## TEXAS NATURAL RESOURCE CONSERVATION COMMISSION

Re: Interim Corrective Measure  
Installation of Protective Cover-ARCHON Areas  
TNRCC Industrial Solid Waste Registration No. 30121  
TNRCC Hazardous Waste Permit No. HW-50188  
EPA ID No. TXD008097529

Re: Closure Plans for West and Southwest Consolidation Areas  
Notice of Deficiency  
Solid Waste Registration No. 30121  
Hazardous Waste Permit No. HW-50188  
EPA ID. No. TXD008097529

Re: Interim Corrective Measures Implementation Workplan  
Approval With Modifications  
Solid Waste Registration No. 30121  
Hazardous Waste Permit No. HW-50188  
EPA ID. No. TXD008097529

Figure 1  
Dredge Spoil Isopach Map  
Star Port Arthur Plant

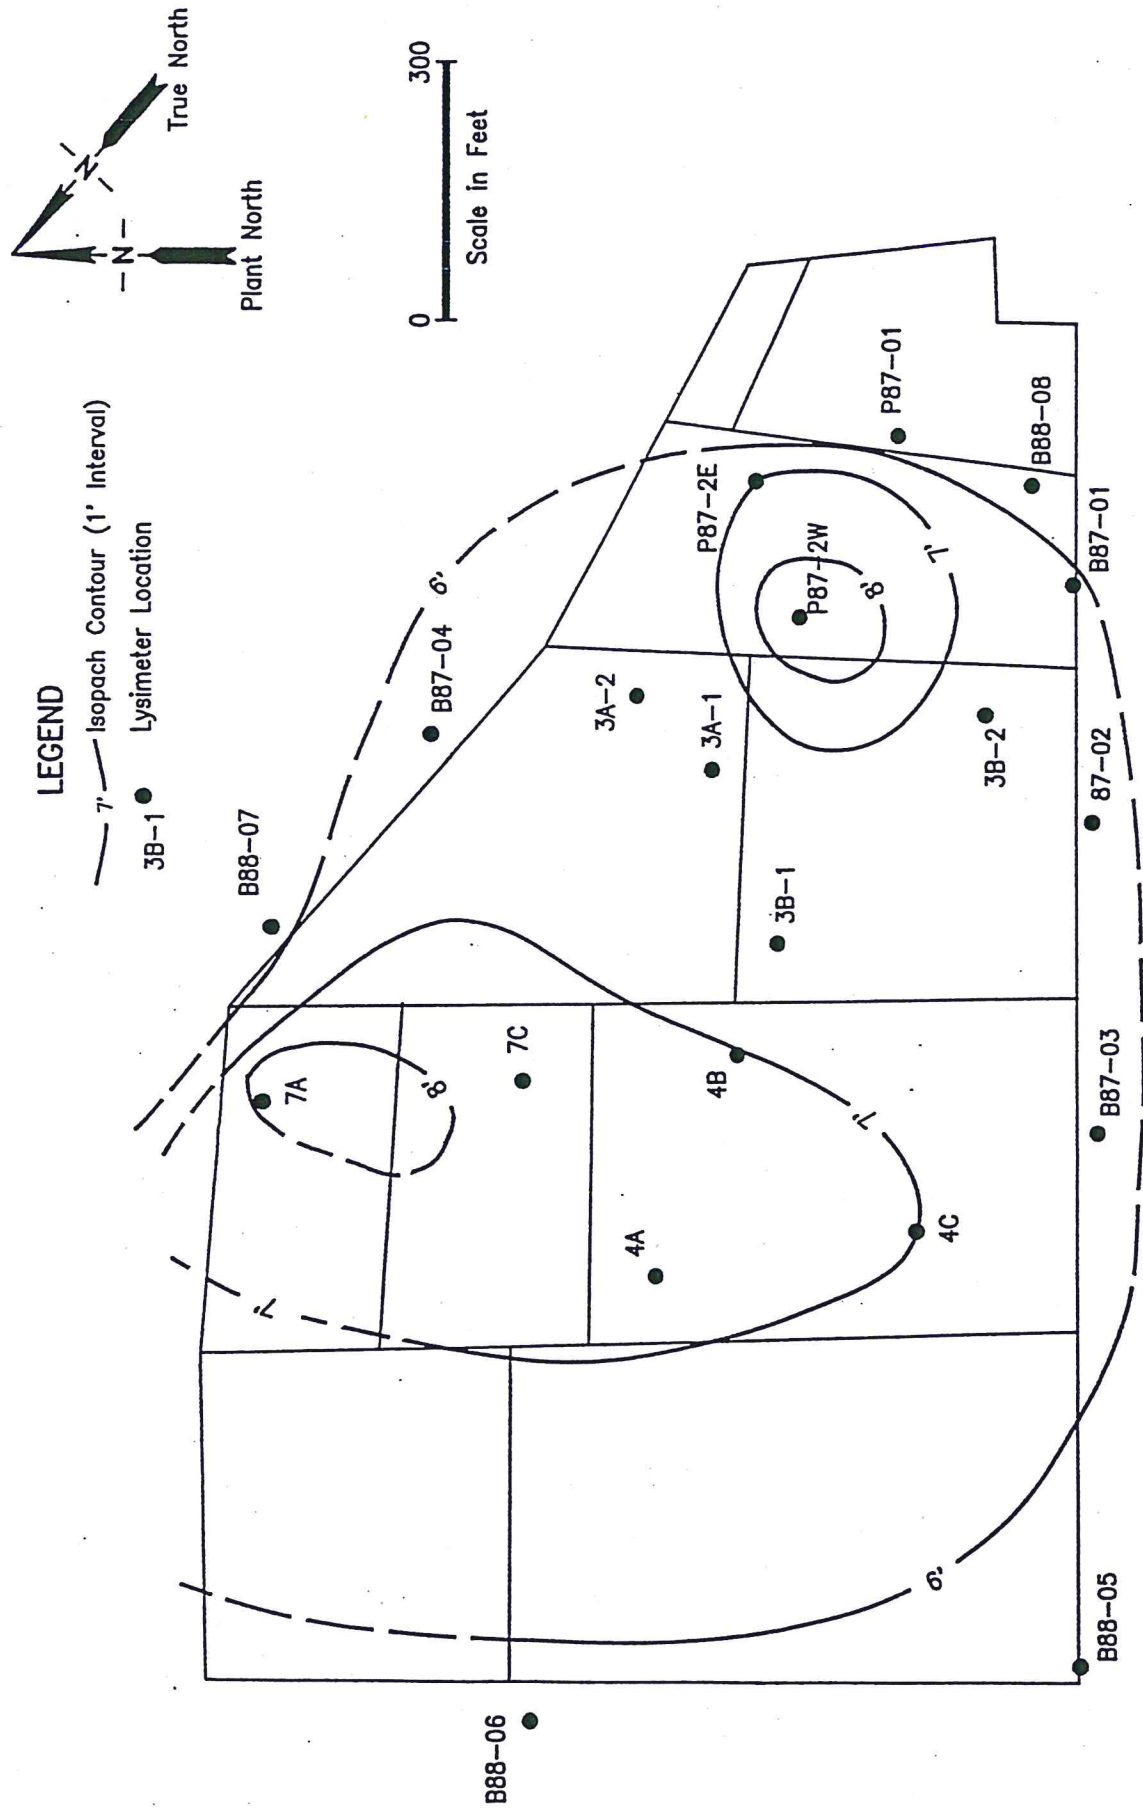
8. It does not appear that the sited provision requires defining the treatment zone. Moreover, as explained in response #1.b), the LTU was constructed over dredge spoils used as fill material to build up the land used by the LTU. Therefore, the dredge spoil and treatment zone thickness varies across the site. The figure presented in Attachment 1 to this letter provides a general isopach map of the dredge spoil thickness based on lysimeter installation trench logs.
